Intel® 5100 Memory Controller Hub Chipset

Specification Update

Revision 005US

Order Number: 318385-005US

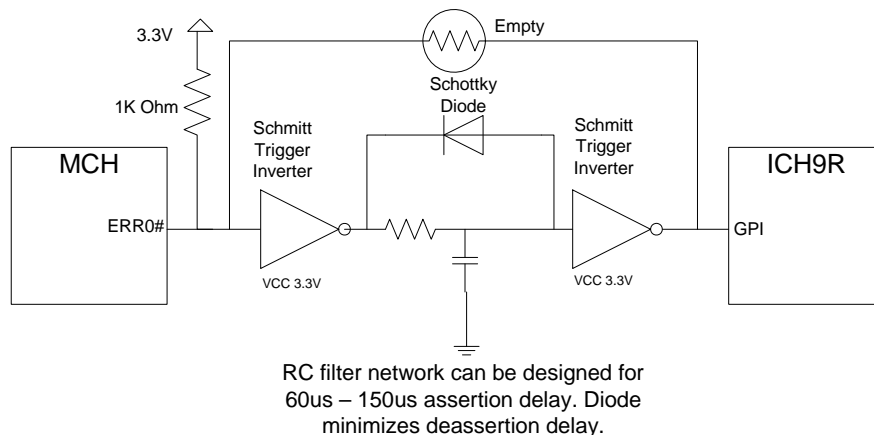
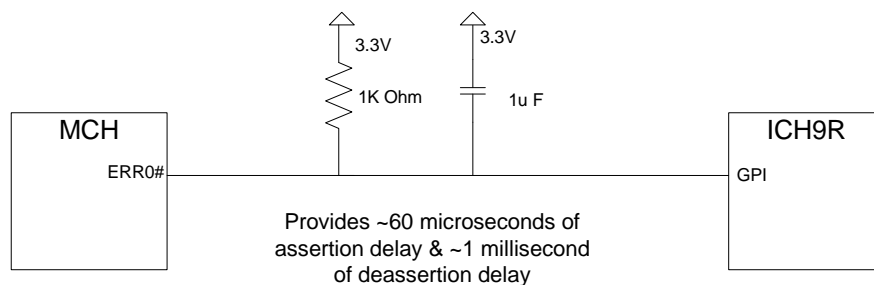
10. SMI escalation via ERR[2:0]# pins may result in IERR#

Problem: Any condition routed to MCH ERR[2:0]# output pins for SMI# escalation that would result in data poisoning on FSB will result in a CPU IERR# assertion due to race condition. The race condition exists between poisoned data presented to the FSB by the MCH and the uncorrectable error escalated to SMI# via ERR[2:0]# pins. If the CPU observes an SMI# assertion before the poisoned data is presented to the FSB, the CPU asserts MCERR# followed by IERR#. The CPU expects the SMI# assertion to occur at least ten BCLKs after the associated MCERR# assertion. Conditions that result in data poisoning on the FSB are uncorrectable memory ECC errors or poisoned TLPs received from any PCI Express* port.

Implication: CPU may assert IERR# and cause a system hang before the error may be logged in SMM.

Workaround: Any one of the three workarounds that have been identified may be selected.

2. Delay SMI# assertion by inserting a 60–150 µs delay on the ERR0# pin

- Two recommended circuit solutions (other solutions may be possible):

- Route errors that result in FSB data poisoning to the ERR0# pin (IO4, M1)

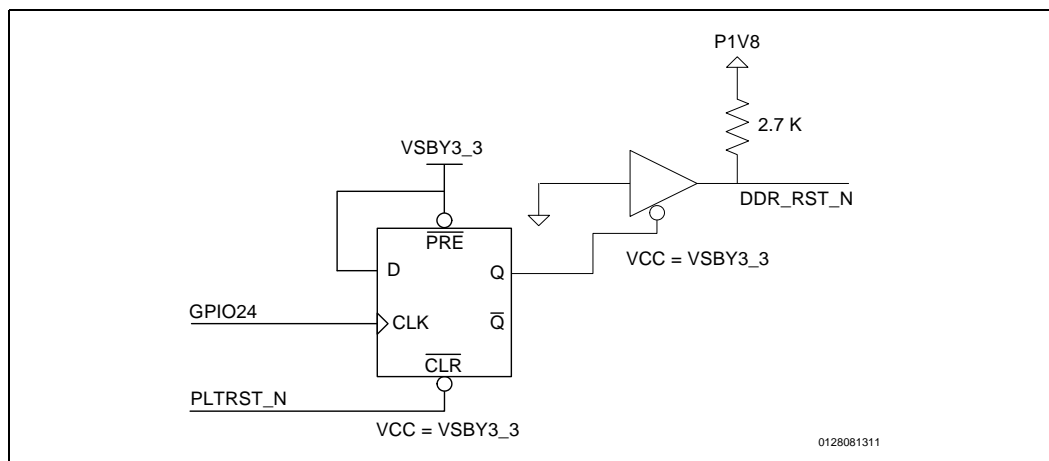
41. Incorrect CKE behavior during recovery from S3 suspend

Problem: During the initial stage of exit from System Sleep State "S3" (suspend to RAM), the CKE signal is driven to an indeterminate state (High, Low, or tristate).

Workaround: The workaround requires both a board-level circuit and a BIOS change. The workaround holds the DIMMs in reset using a flipflop clocked by a GPIO from the ICH9R under control of the BIOS. An output controlled buffer is also required to transition the 3.3 V output of the flipflop to the 1.8 V reset input of the DIMM (see diagram below). The possible GPIOs are GPIO[28,27,24,12]. The GPIO implemented in the circuit is incorporated into the BIOS as a build option by an Intel BIOS Vendor (IBV).
